Amendment to the Drawings:

- - REMARKS - -

Annotated
Sheet

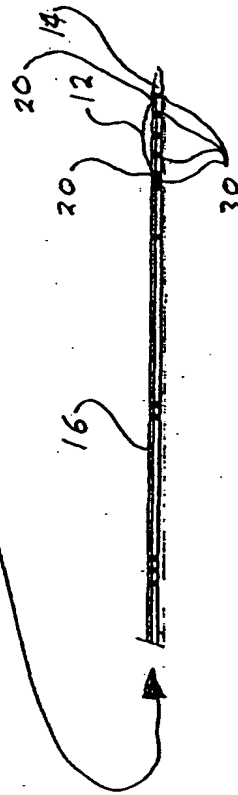
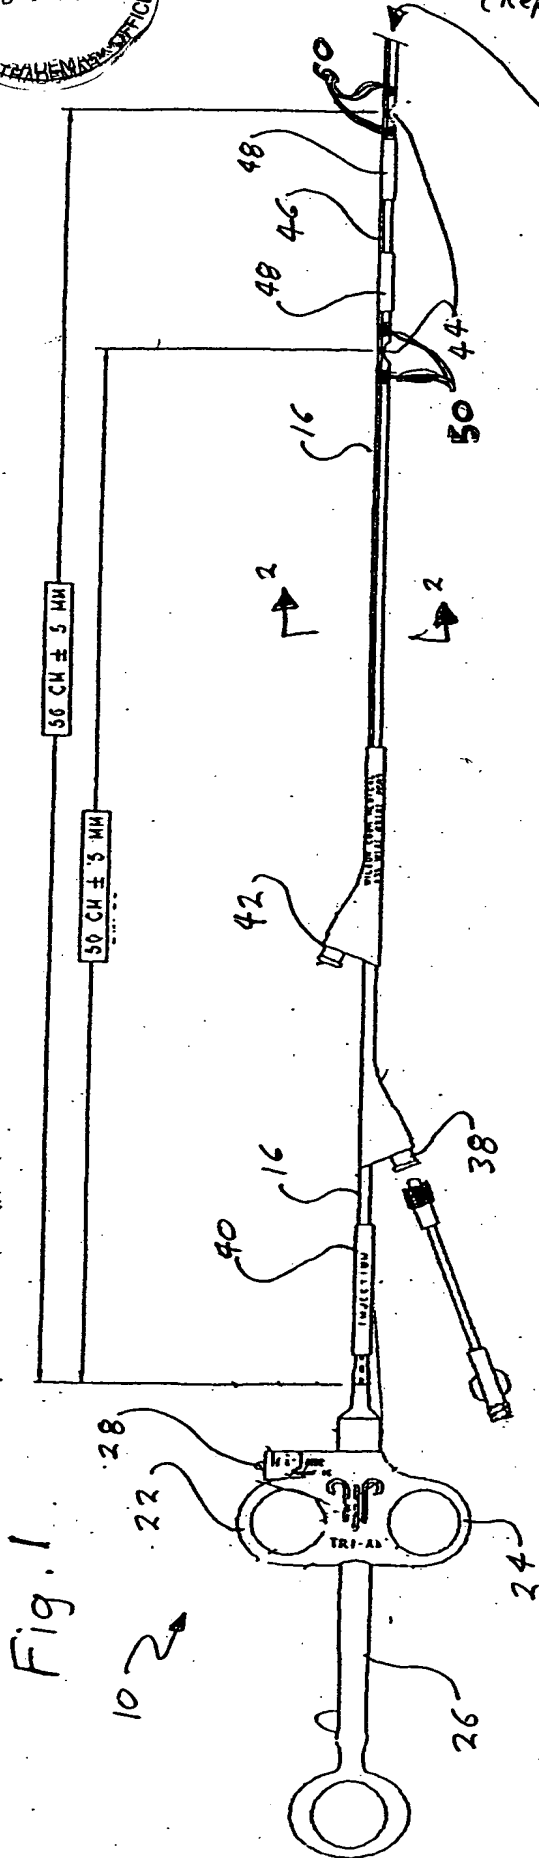
Please replace original drawing sheets 1/2 and 2/2 with the corrected Replacement Sheets 1/3 and 2/3 attached hereto. The corrected drawing sheets include the addition of element numbers to Figs 1 and 3. The changes to the drawings are shown in red on the Annotated Mark-up Drawings that are likewise attached hereto.

In the outstanding Office Action, the drawings have been objected to under 37 CFR 1.83(a) because the figures purportedly fail to show certain features or element numbers described in the specification. As a consequence, the drawings have been amended to include the missing element numbers and features. In particular, Figure 1 has been amended to include an element number (50) referencing the markers adjacent to the intermediate wire guide access ports, as those markers are described in paragraph [0026] of the specification. A corresponding amendment has been made to paragraph [0026]. In addition, Figure 3 has been amended to include element numbers (42, 44 and 48) that are shown in Figure 1 and described in, for example, paragraph [0024] of the specification. A Figure 3A has also been added to illustrate the arrangement described in the last two sentences of paragraph [0024] of the specification, i.e., wherein the more distal intermediate access port (44) may end up inside the handle (64) of the endoscope (60). A reference to Figure 3A has been added to paragraphs [0017] and [0024]. Applicants believe that the Examiner's objections to the drawings under 37 CFR 1.83(a), particularly with respect to the non-cancelled claims, have been overcome by the corrections to Figures 1 and 3, and the addition of new drawing Figure 3A.
